Addendum No. 1
Item No. 5
Volume 3

CITY OF BULLHEAD CITY

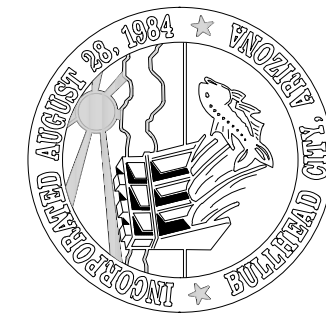
DESIGN: JCM	DATE: 05/2026	REVISION	DATE	DESCRIPTION
		1	7/7/26	ADDENDUM NO. 1

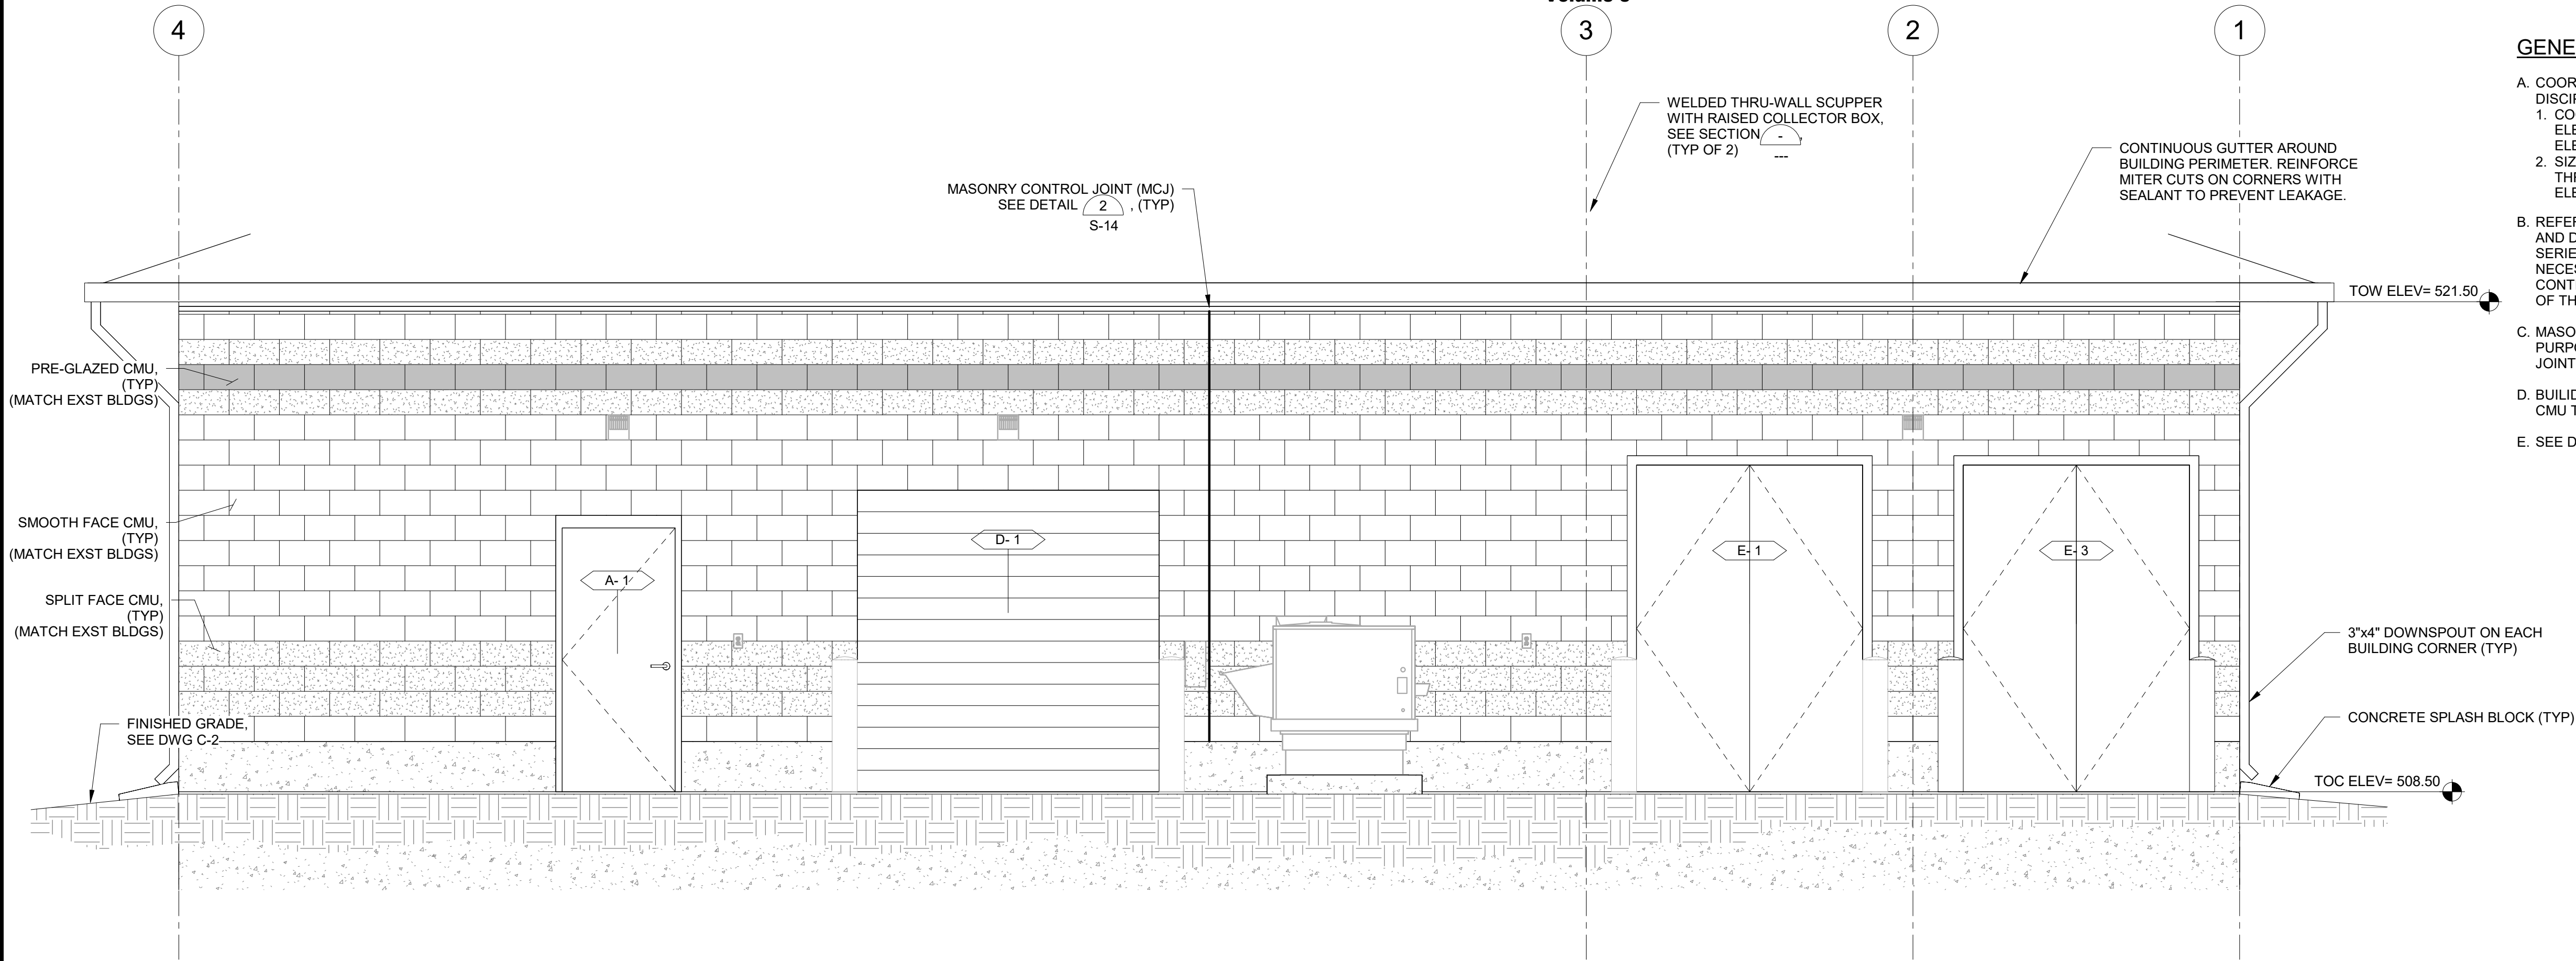
Addendum No. 1
Item No. 5
Volume 3

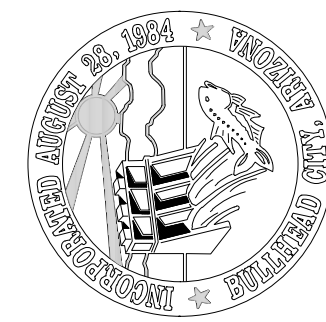
DESIGN: JCM	DRAWN: DAH	CHECKED: JCM
DATE: 05/20/26		
REVISION	DATE	DESCRIPTION
1	7/7/26	ADDENDUM NO. 1
		RL

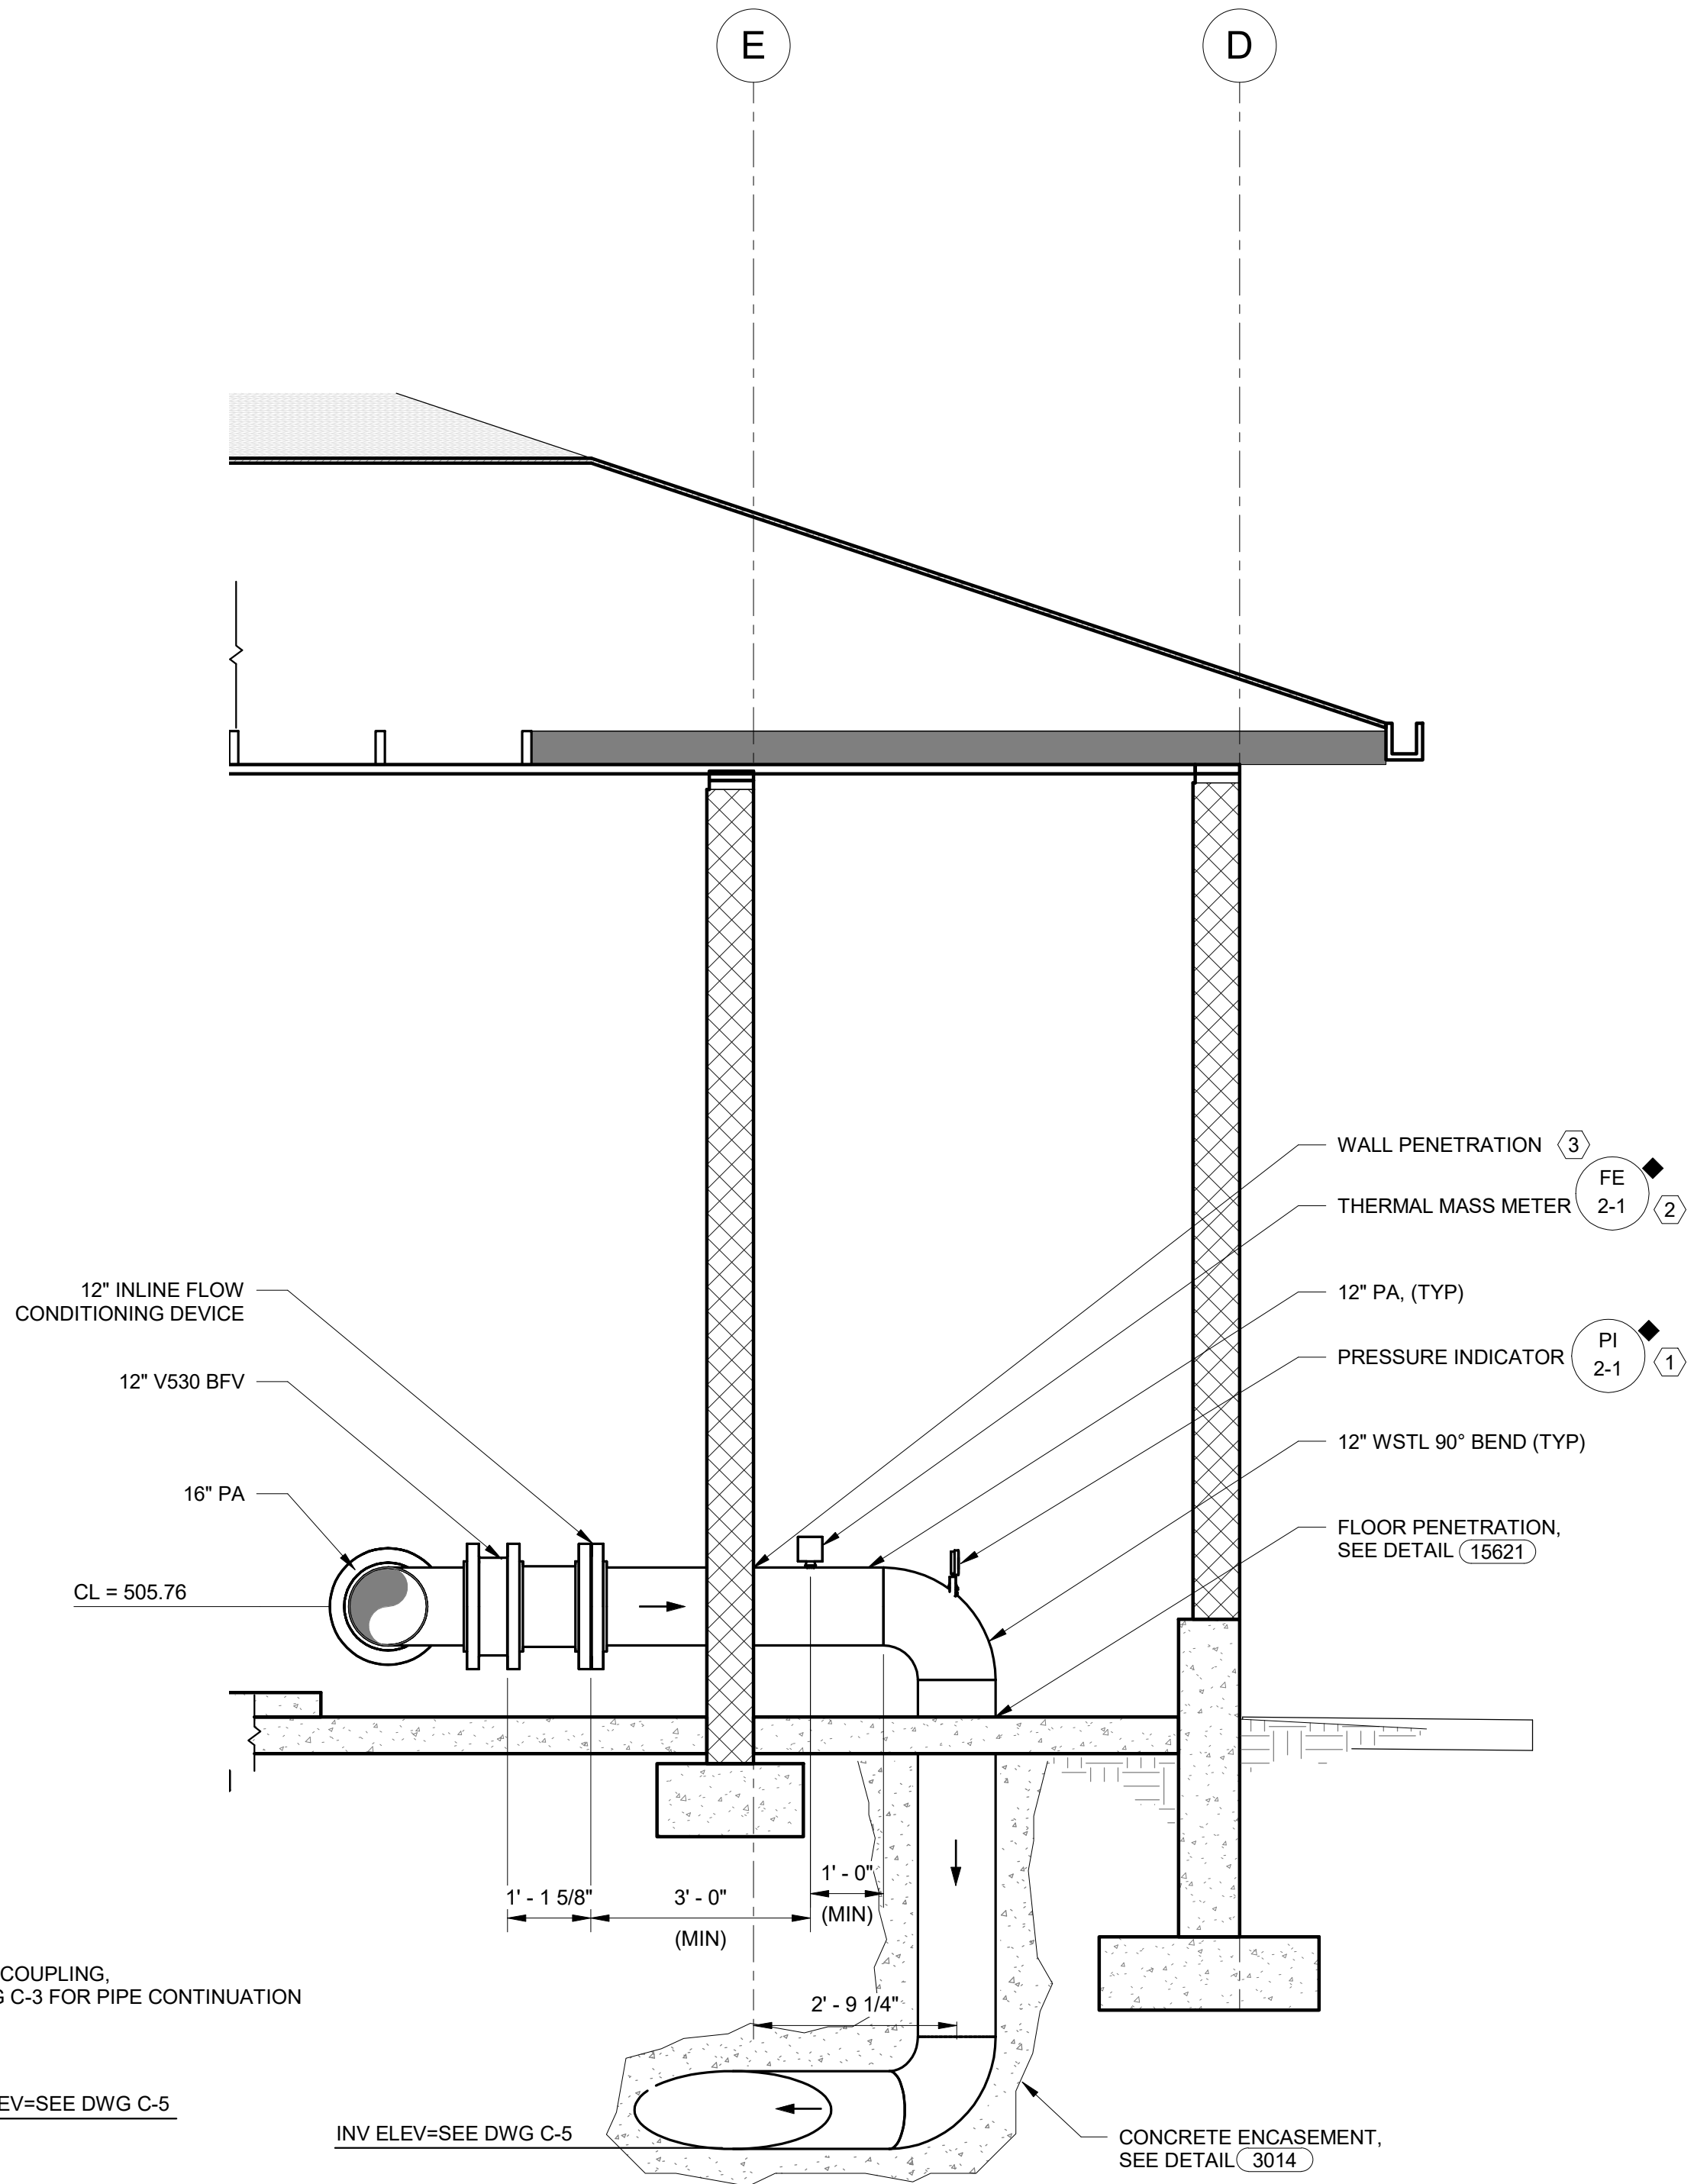
DESIGN: ECS	DATE: 05/20/26	REVISION	DATE	DESCRIPTION
		1	7/7/26	ADDENDUM NO. 1
				RL

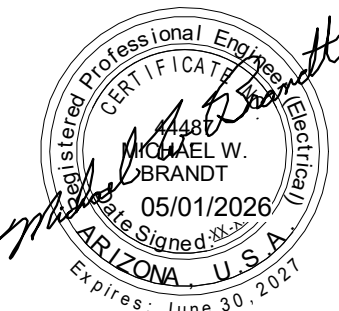
ADDENDUM NO. 1

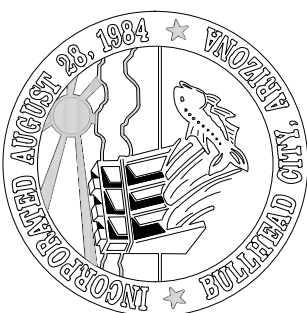
DESIGN: MWB	DRAWN: MH	CHECKED: BCL
DATE: 05/20/26		
REVISION	DATE	DESCRIPTION
1	7/7/26	ADDENDUM NO. 1
		MWB

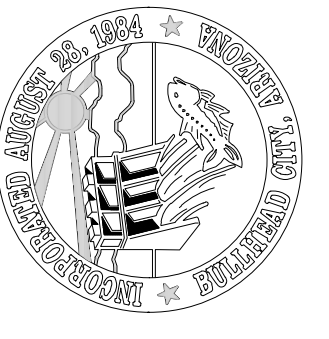
DESCRIPTION
ADDENDUM NO. 1

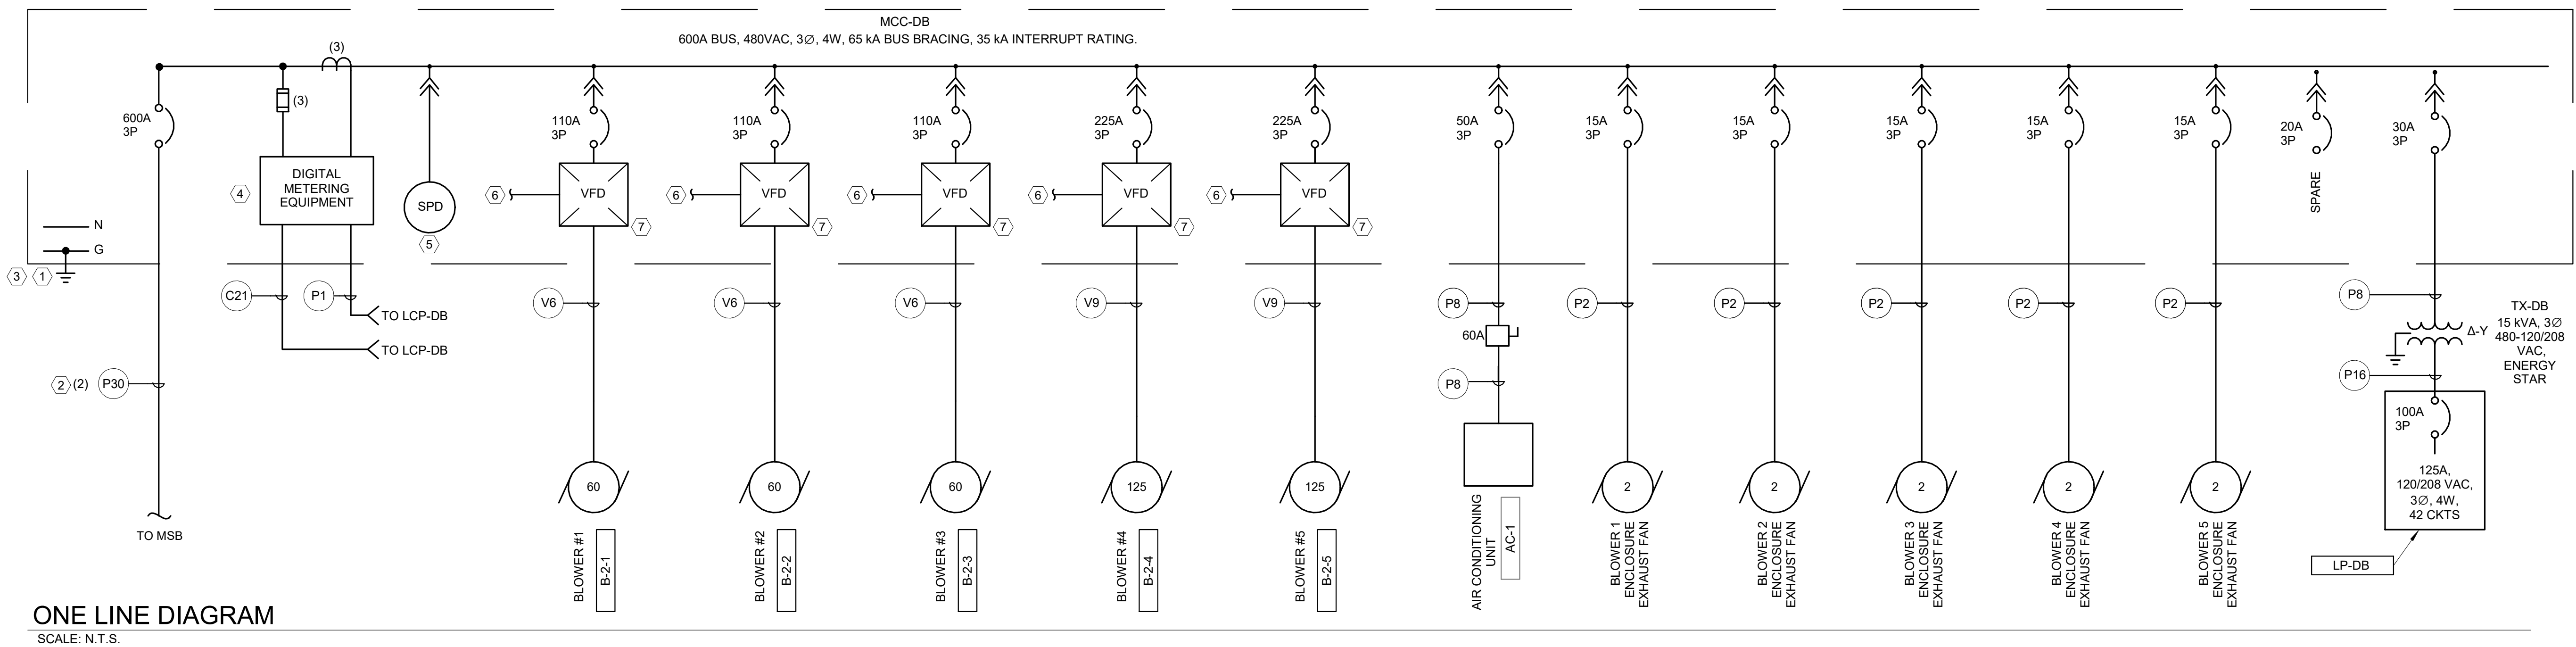
Addendum No. 1
Item No. 5
Volume 3

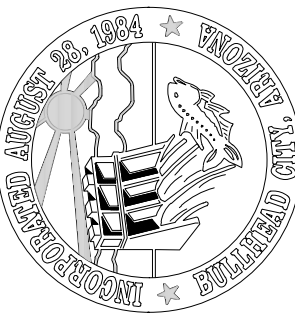
DESIGN: MWB	DATE: 05/20/26	REVISION	DATE	DESCRIPTION	CHECKED: BCL
1	7/7/26	ADDENDUM NO. 1		MWB

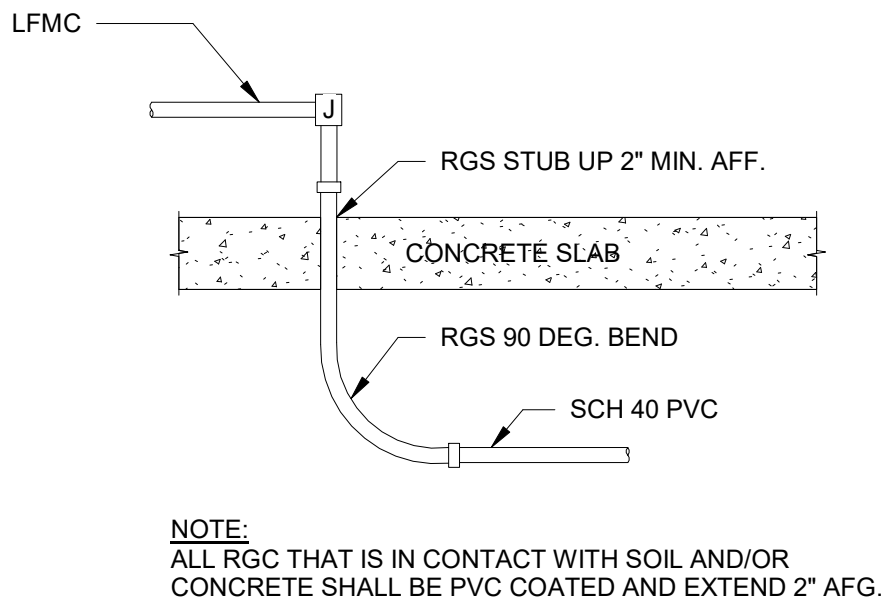
DESCRIPTION
ADDENDUM NO. 1

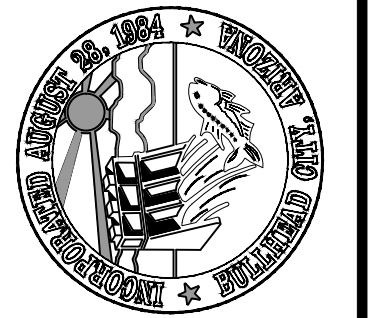
BULLHEAD CITY SECTION 10				DESIGN: ECS	DRAWN: JAC	CHECKED: JCM
				DATE: 05/2026		
BLOWER BUILDINGS IMPROVEMENTS				REVISION	DATE	DESCRIPTION
				1	7/7/26	ADDENDUM NO. 1
						RL
DIGESTER BLOWER BUILDING PID 1
